# 1963 - 1964 Corvette: Service Bulletin: 3-Speed Transmission Problems

**Bulletin No:** TSB #1008 DR #676

**Date:** July 16, 1964

FIGURE 2 - MAST JACKET ASSEMBLY

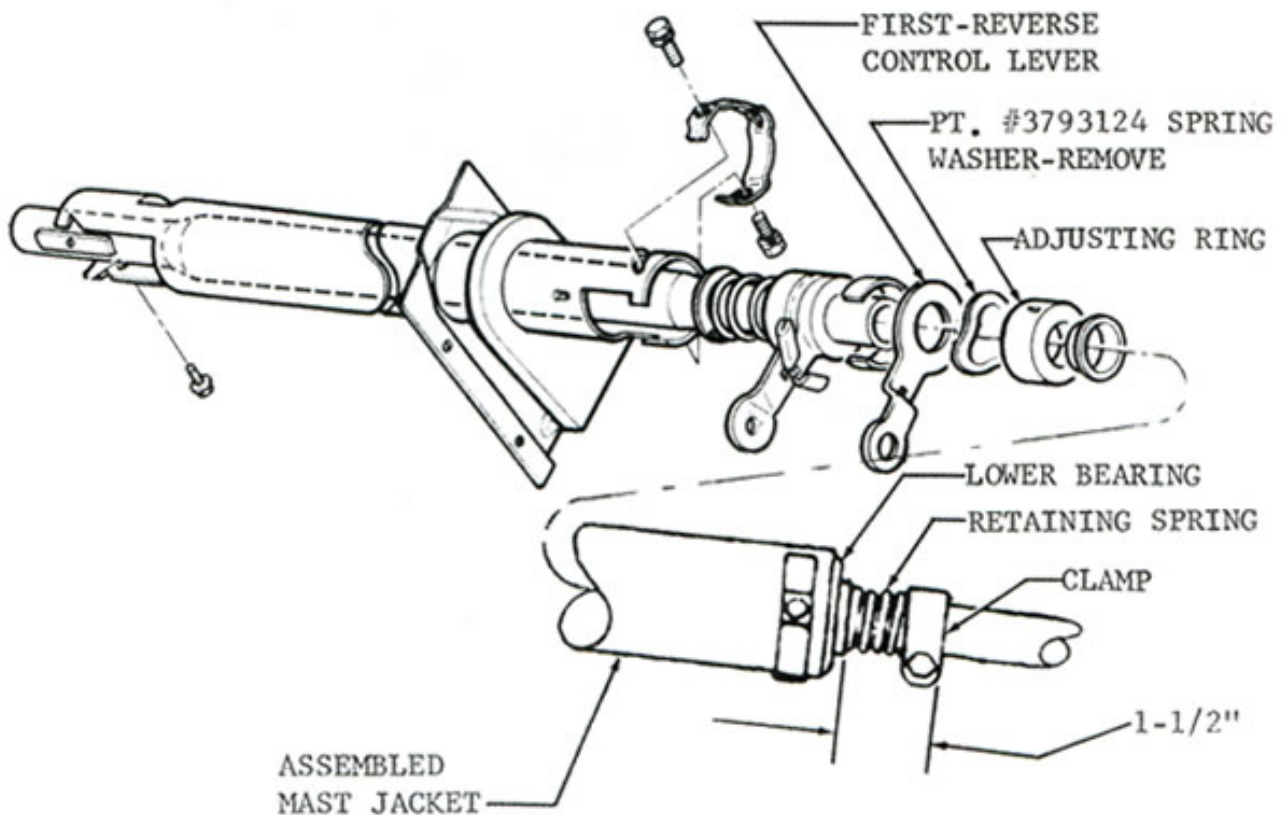
To provide a more positive shift on truck models, Part No. 3793124, transmission control 1st and reverse lever spring washer is being omitted in production and should be removed from units in service. The procedure to remove this spring washer and to readjust lever clearance is as follows:

1. Refer to Figure 2 for parts identification. Place shift lever in neutral; remove access cover from fender skirt.

2. Remove cap screws retaining adjusting ring to mast jacket.
3. Loosen steering shaft lower bearing retaining spring clamp.
4. Slide adjusting ring downward along steering shaft until Part No. 3793124, spring washer, is exposed. Cut and remove spring washer from steering shaft.
5. Apply lubriplate to thrust surfaces of control levers, relay lever and adjusting ring.
6. Position adjusting ring in mast jacket; align holes in ring with slots in mast jacket and install cap screws, but do not tighten.
7. Rotate adjusting ring upward until clearance of .005" exists between first-reverse control lever and ring as shown in Figure 3. Tighten cap screws.

8. Force lower bearing retaining spring clamp upward against spring tension until a dimension of 1-1/2" exists between lower bearing and clamp as shown in Figure 2. Tighten clamp bolt.
9. With transmission side cover selector levers in neutral position, adjust selector rod lengths per instructions in the appropriate shop manual to provide proper neutral cross-over. Replace access cover when adjustments are completed.

FIGURE 4 - INSTALLATION OF THRUST WASHERS IN CHEVY VAN

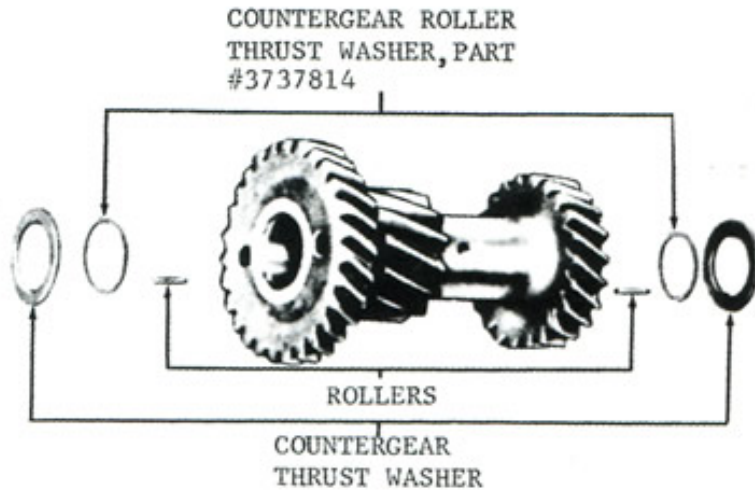
On Chevy Van models with three-speed transmissions, a small steel thrust washer is used between the countergear thrust washer and the countergear roller bearings at each end of the countergear. Since the 1964 Chevy Van Shop Manual is supplemented to the 1963 Truck Shop Manual in this area, reference to this part is omitted in error.

Figure 4 illustrates installed location of this thrust washer in Chevy Van transmissions.

FIGURE 5 - INSTALLATION OF MAGNETIC CHIP COLLECTOR

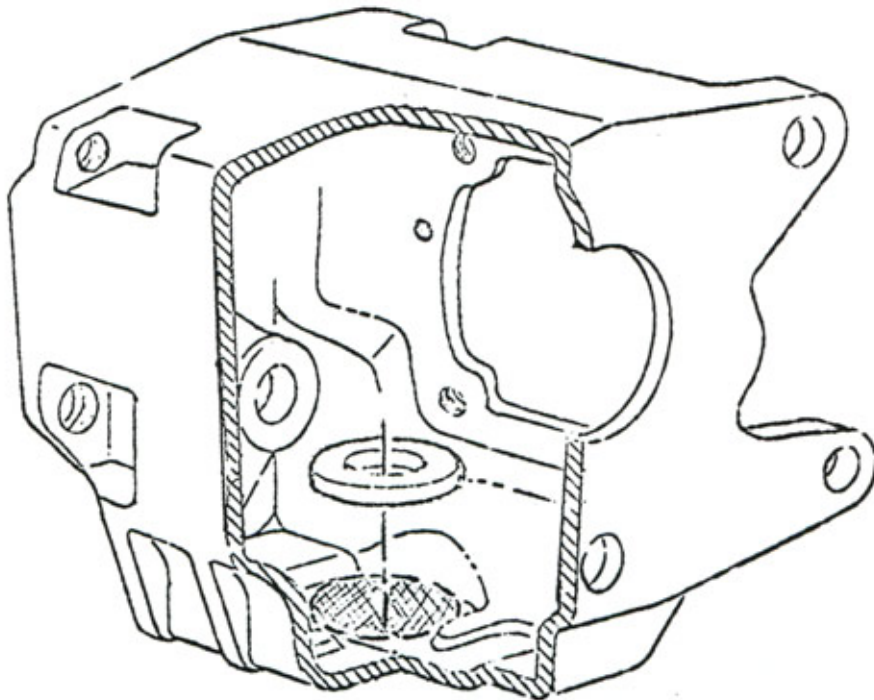
3. Wipe magnet and area in case where magnet is to be installed with Acetone or Toluol (available at most drugstores). Area where magnet is to be installed must be clean, dry and free from oil and grease film. When Acetone or Toluol is applied, be sure to use in ample quantity to neutralize grease and oil which may be in pores of casting surface. Do not touch cleaned area with hands.

4. Using cement supplied in kit, apply about a 1/16 inch thick film over entire bottom surface of magnet and immediately place in case as shown in sketch. Press straight down - do not twist while pressing in position. Note: If cement from tube appears to be thick, discard thick or hardened chunks and use cement from middle or bottom of tube.

5. To cure cement, place a trouble light with a 100 watt lamp inside of case as close to magnet as possible, and allow to stand for a minimum of 30 minutes. Use care not to touch magnet or knock it out of position. A heat lamp, if available, may be used in place of 100 watt lamp.
